Riley Purgatory Bluff Creek Watershed District Permit Application Review

Permit No: 2023-074

Project: Trunk Highway 101 Rehabilitation and Culvert Improvement – The proposed project includes bituminous mill and overlay of TH101, Americans With Disabilities Act Improvements, trail reclamation/rehabilitation, signal revisions, drainage preservation work and modifications to an existing culvert that conveys Purgatory Creek under the roadway.

Reviewer: Scott Sobiech, PE, Barr Engineering

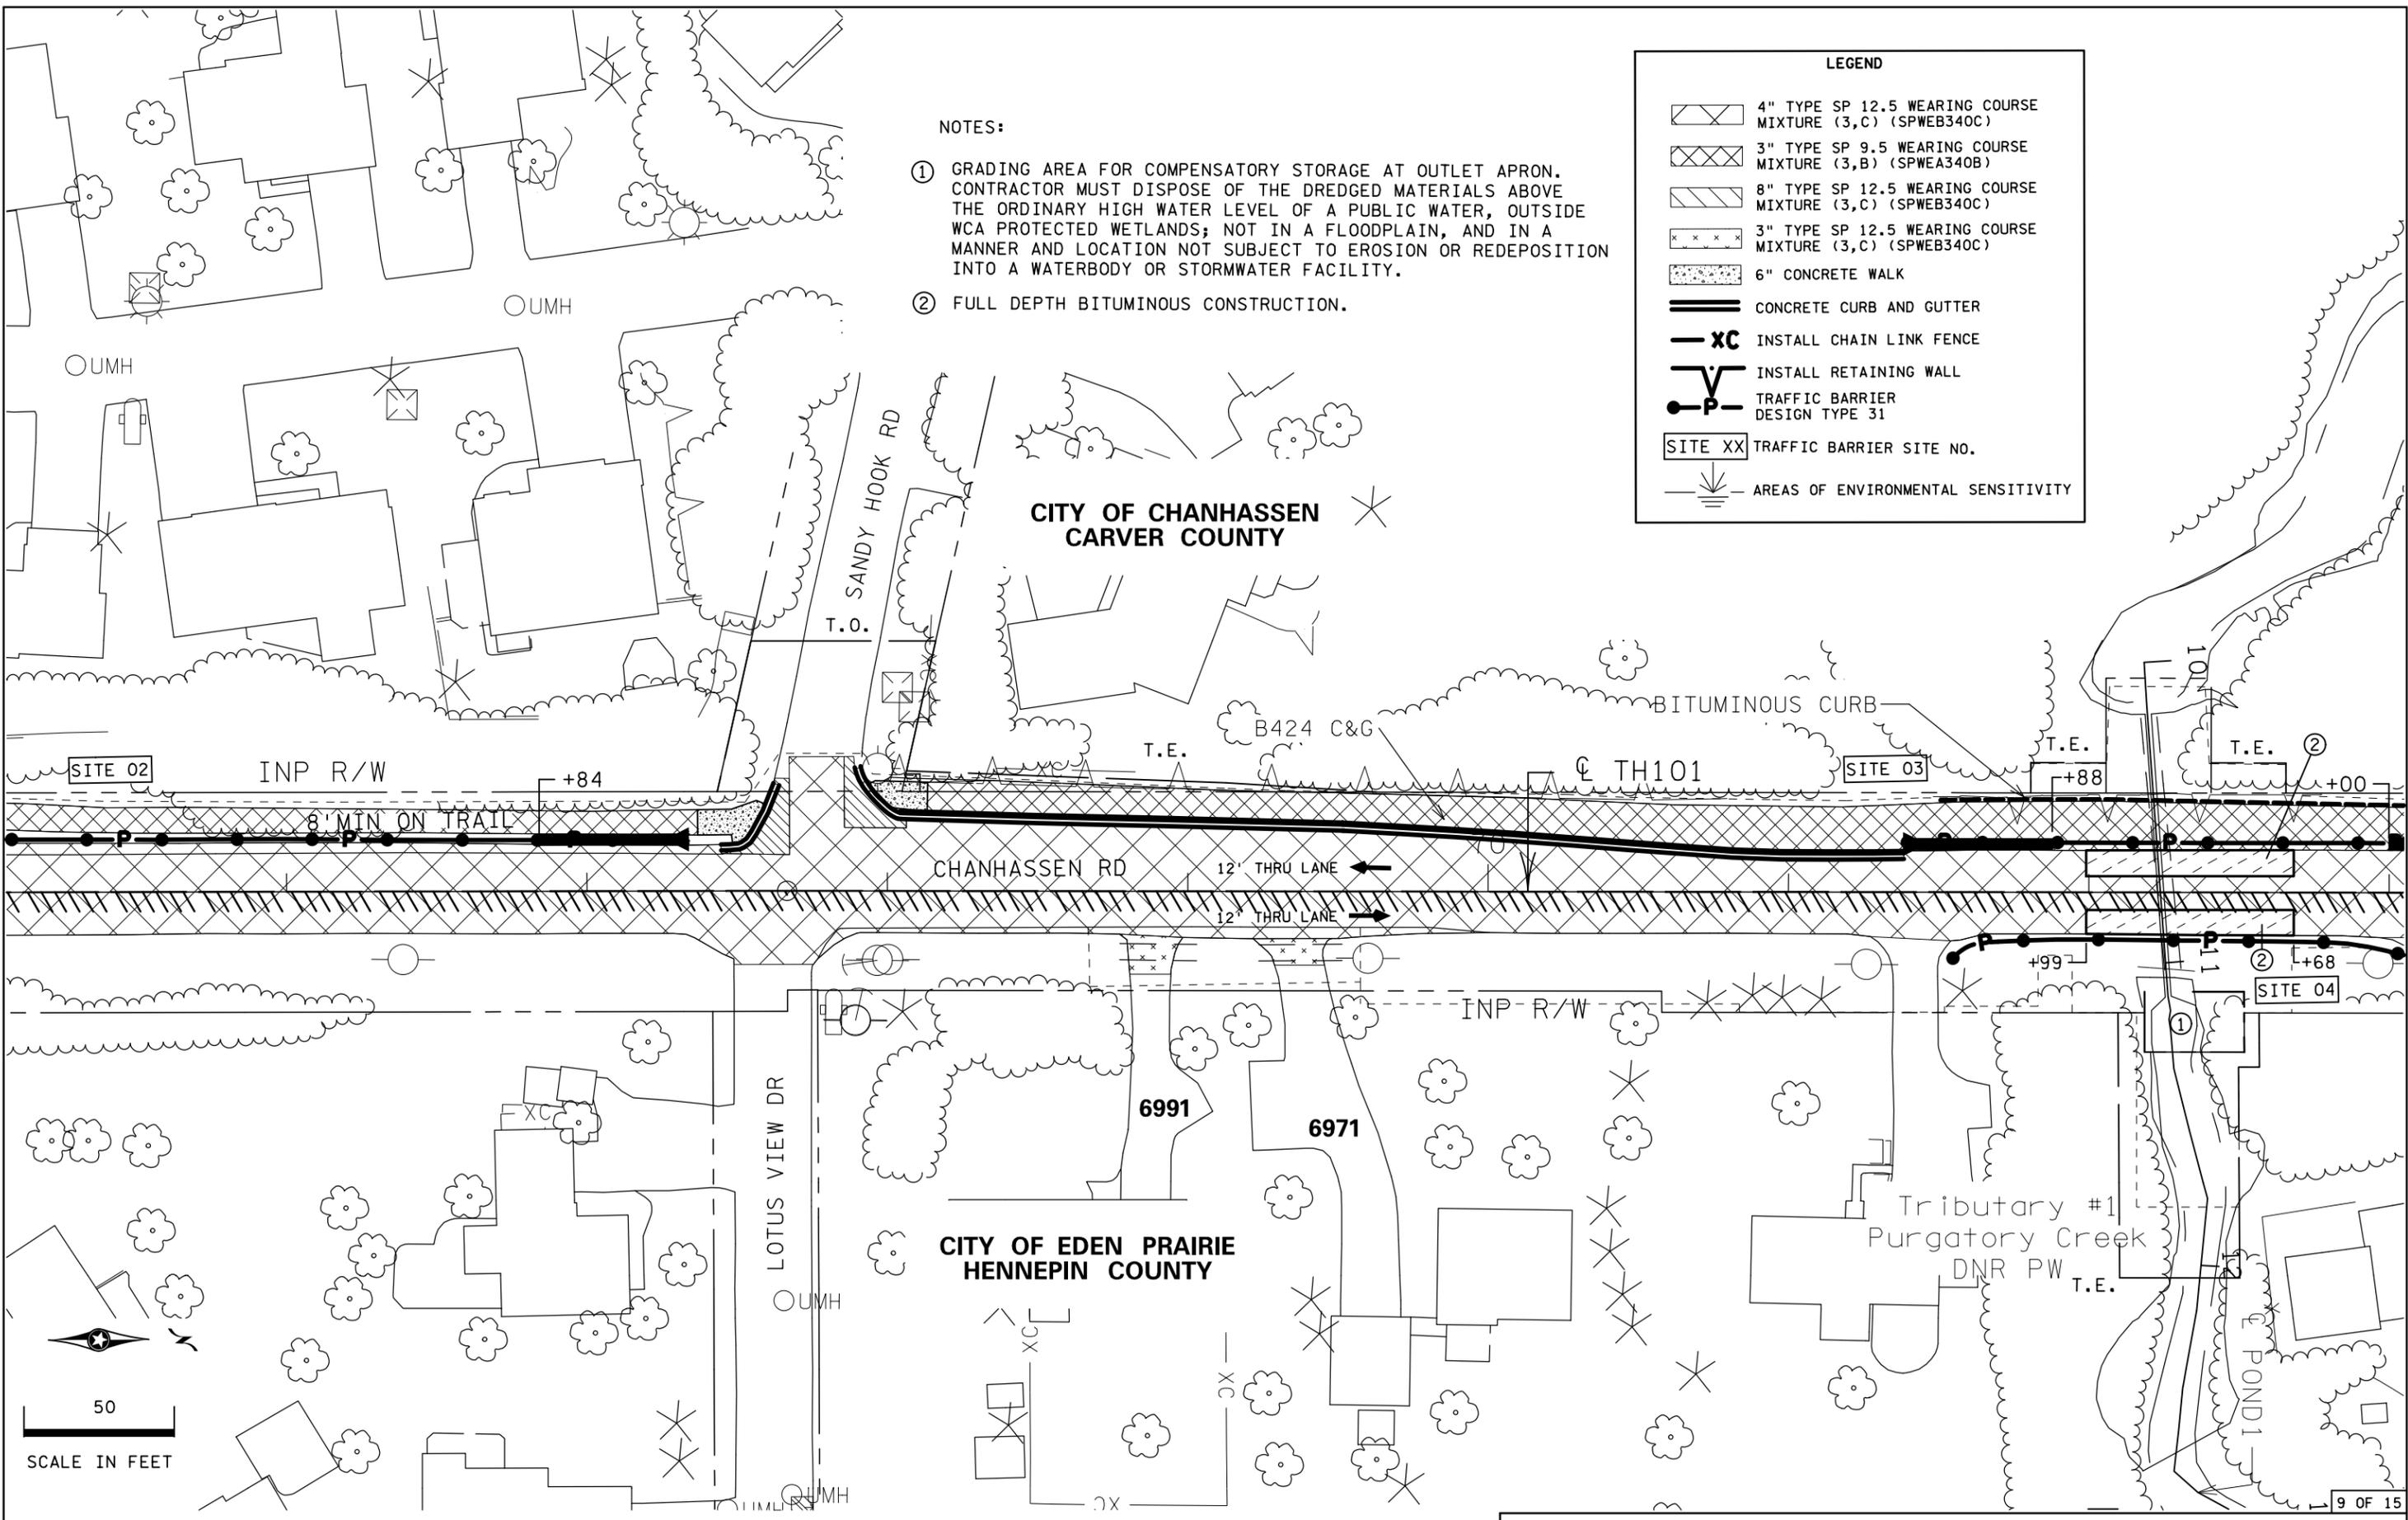
Because a note on sheet 114 requires the contractor to dispose of dredged materials above the ordinary high water level of a public water, outside WCA protected wetlands; not in a floodplain, and in a manner and location not subject to erosion or redeposition into a waterbody or stormwater facility, the project conforms with Rule E, Subsection 3.2. A note on the site map directs the contractor that no work affecting the bed or banks of a protected water shall occur between March 15 and June 15 (Rule E, Subsection 3.5). Banks will be immediately stabilized after completion of permitted work and revegetated as soon as growing conditions allow (Rule E, Subsection 3.3) and the plans call for the installation of floating silt curtain (Rule E, Subsection 3.4). A note is included on the plan sheet indicating the project will be constructed so as to minimize the potential transfer of aquatic invasive species (e.g., zebra mussels, Eurasian watermilfoil, etc.) to the maximum extent possible (Rule E, Subsection 3.6).

SHEET NO. 156 OF 162 SHEETS

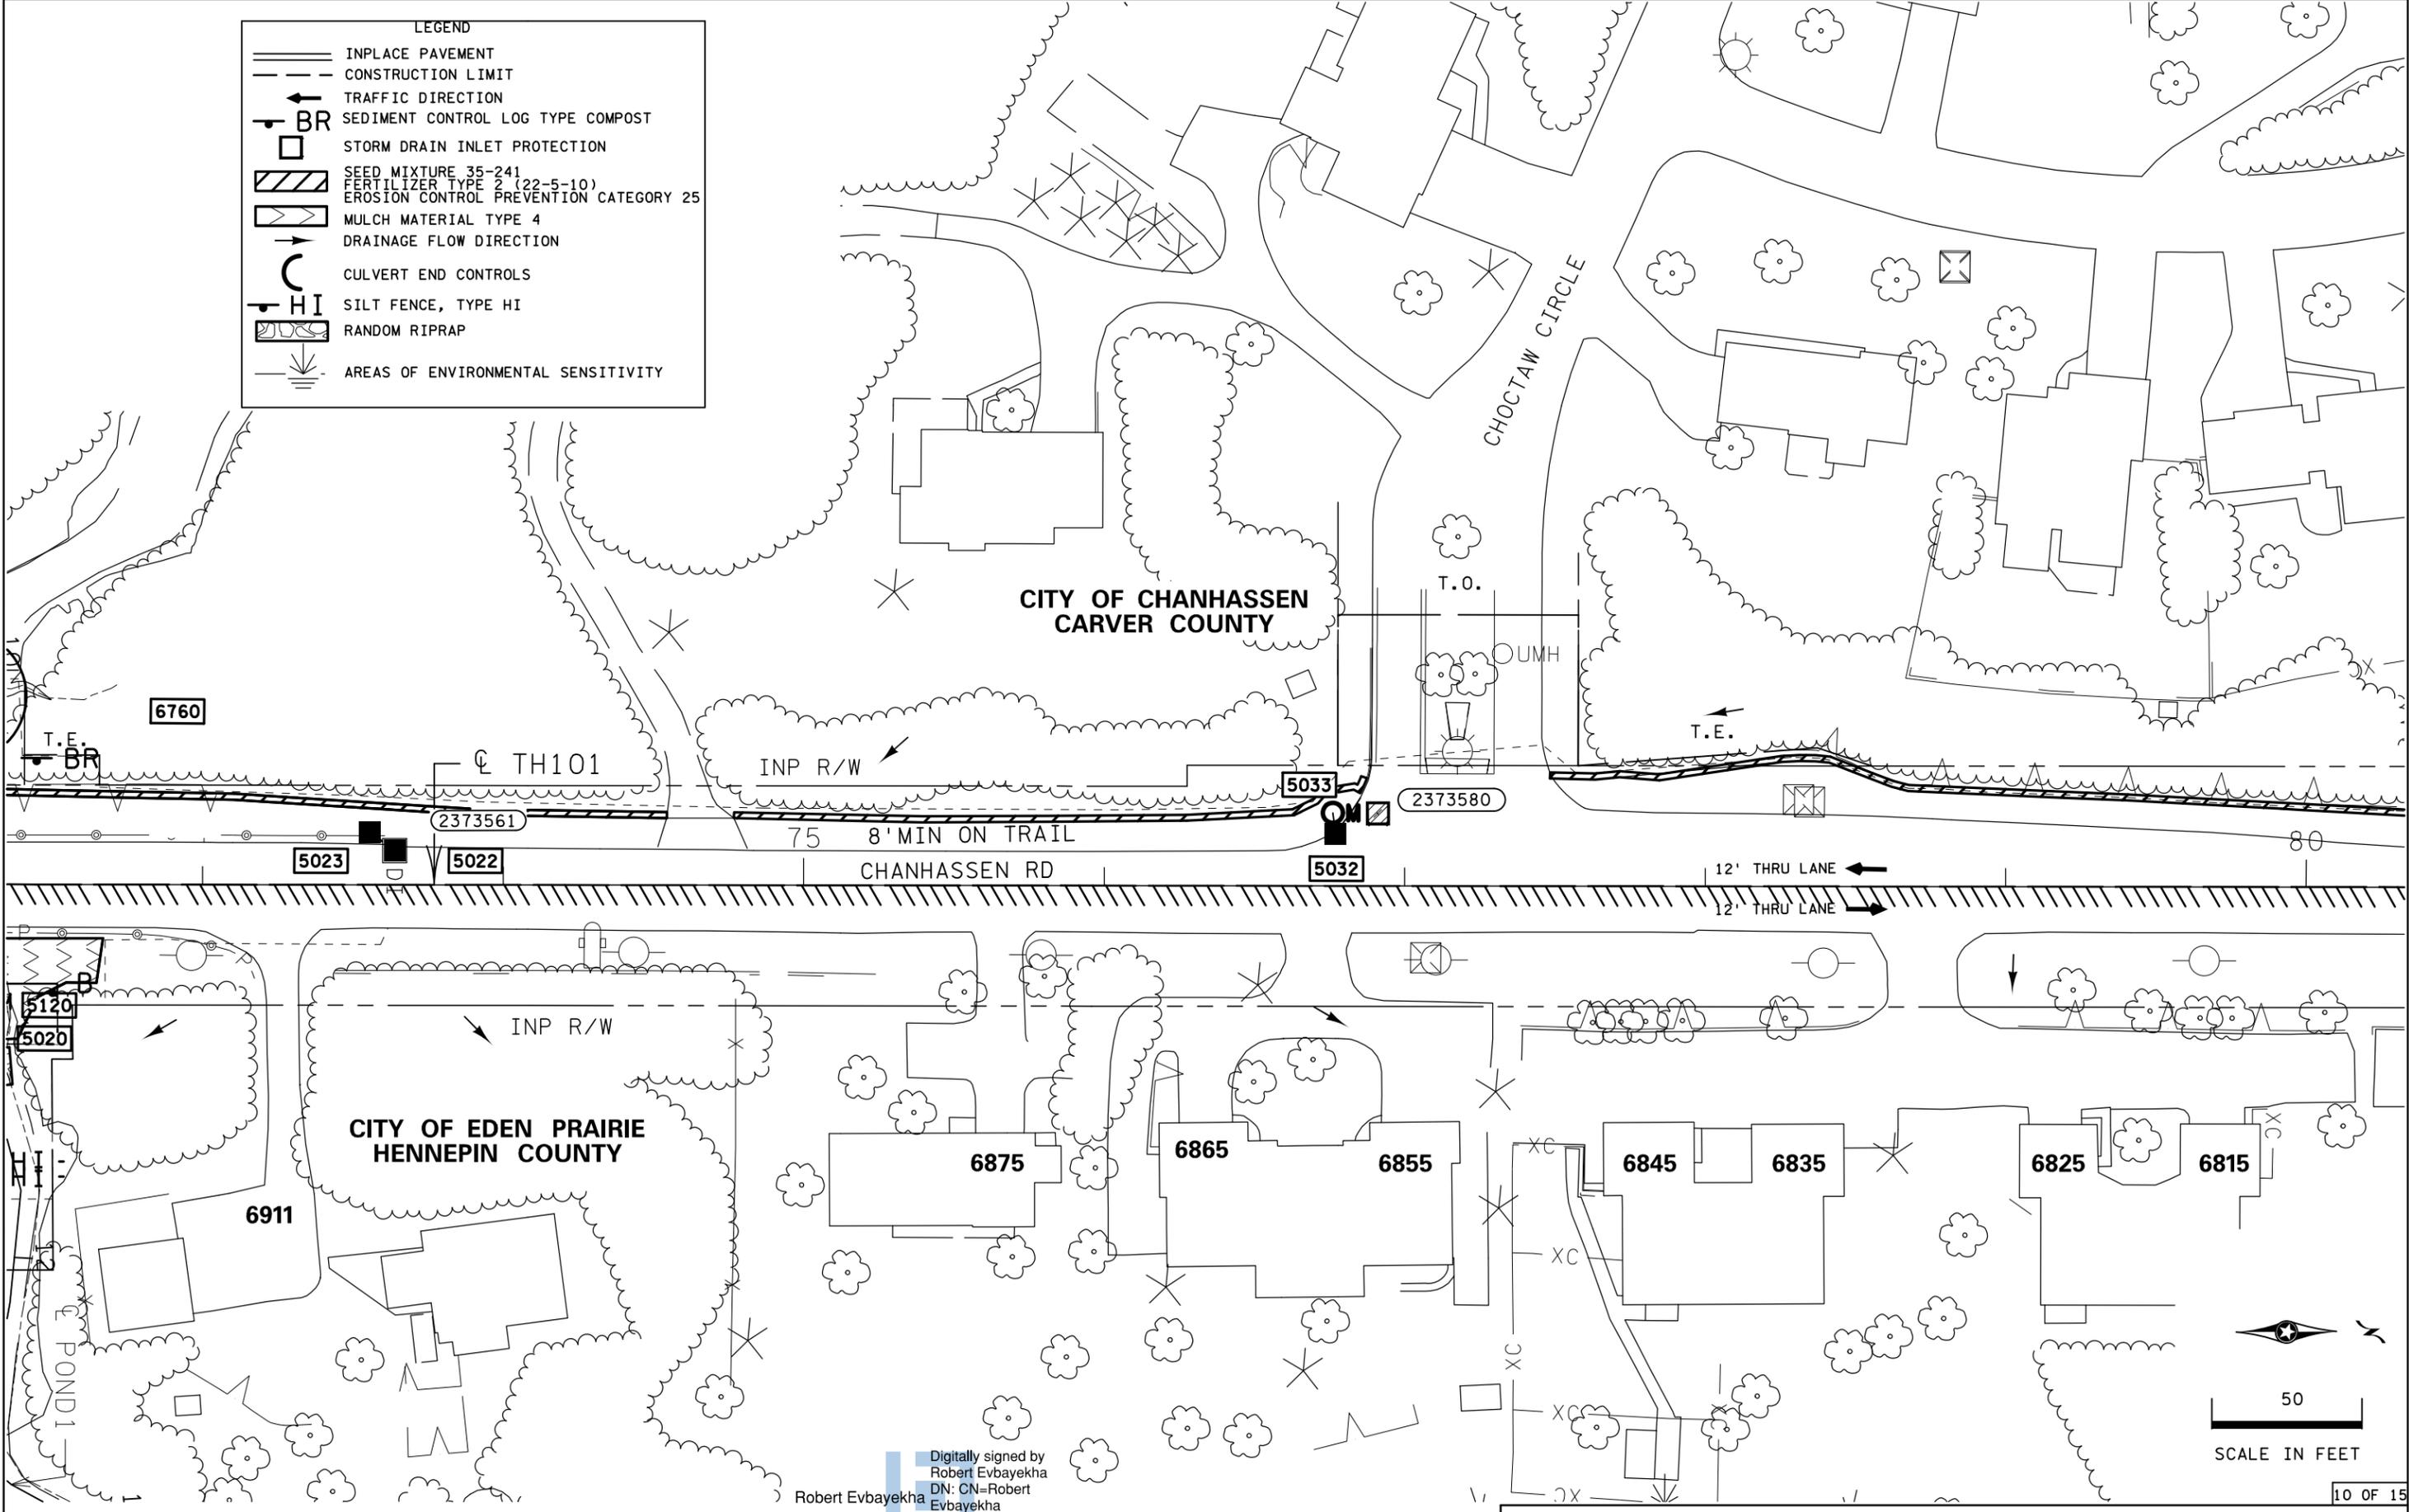
The erosion control and turf establishment plans (sht 156 of 162) indicate the Applicant is proposing revegetating disturbed areas within the proposed buffer with native vegetation in conformance with Rule D, Subsection 3.3. A note is included on the plan sheet indicating the project will be constructed so as to minimize the potential transfer of aquatic invasive species (e.g., zebra mussels, Eurasian watermilfoil, etc.) to the maximum extent possible conforming to Rule D, Subsection 3.5.
